Land-Rover Service Newsletter Vol. 3 No. 3

January 1969

The Rover Company Limited Service Department: Solihull, Warwickshire, England

Fig. 1 Sediment bowl and filter

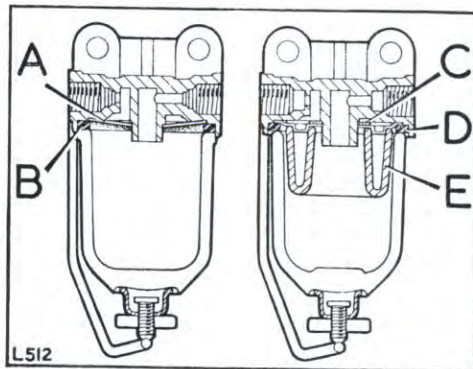
Instances of carburettor flooding have been reported. Our investigations have shown that the flooding is caused by impurities in the petrol, which prevent the float chamber needle valve from closing. If necessary, an AC filter, (AC Part No. GF 124—USA manufacture, or FS 2—UK manufacture) can be fitted into the existing sediment bowl, pending the introduction of an improved petrol filter. See Fig. 1.

Remove original parts

A—Gauze filter B—Sealing washer

Replace with parts supplied in kit AC No. G.F. 124 or F.S. 2

C—Inner sealing washer D—Outer sealing washer E—Filter

The replacement period for this temporary AC filter is 4,000 miles (6,000 km). Supplies of AC filters should be obtained through normal trade sources.

Fig. 2 Installation of recirculation heater, 4 cylinder models illustrated

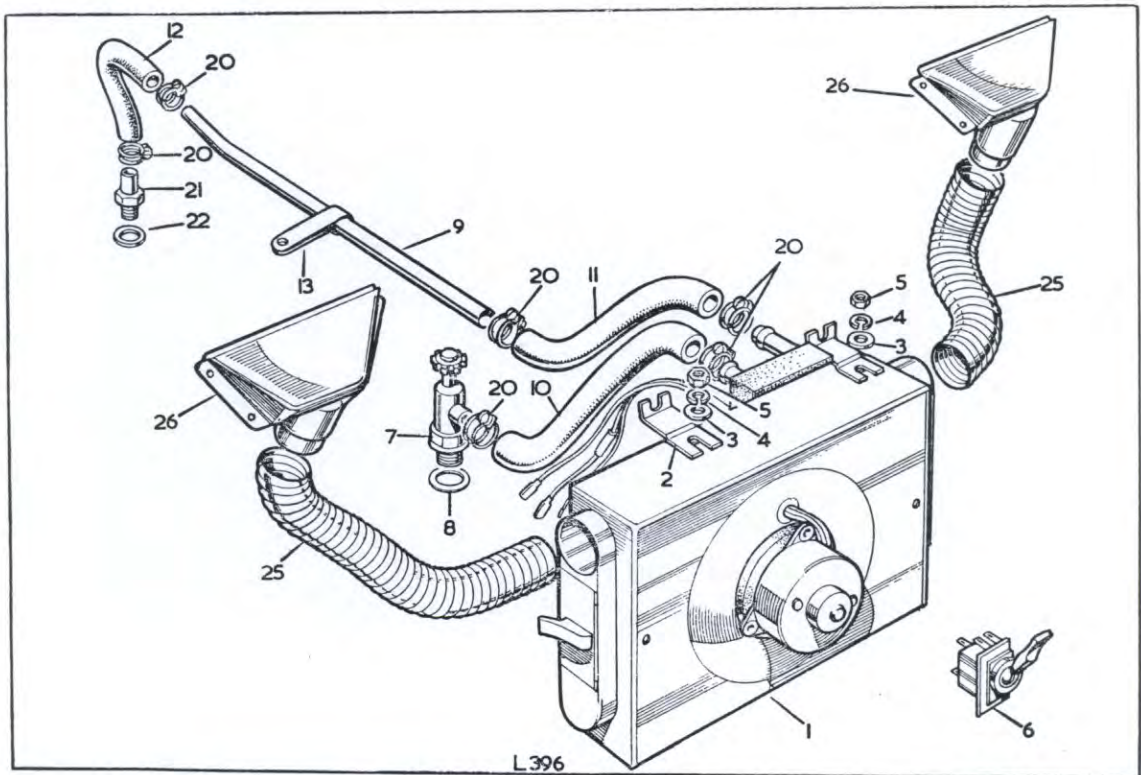
MODIFICATION: Introduction of improved type recirculating heater.

REMARKS: The new recirculating heater has an output of 3.5 KW at maximum fan speed, compared with 2.5 KW output of the early type.
 The new heater also has larger bore demister vents and a two-speed fan that is operated by a three-position switch on the fascia.
 Where a heater and demister is required on a new vehicle, the appropriate 'E' number must be quoted on the New Vehicle Order.
 Heater and demister kits for installation into vehicles already in service are available from our Parts Department under the Part Numbers listed on the previous page.
 For your information details of earlier Land-Rover Series II and IIA recirculation heaters are detailed below. It should be noted there is no interchangeability between any of the part numbers listed:

INTERCHANGEABILITY: Early and late type recirculating heaters are not interchangeable and both types must be stocked to cover all Service requirements.
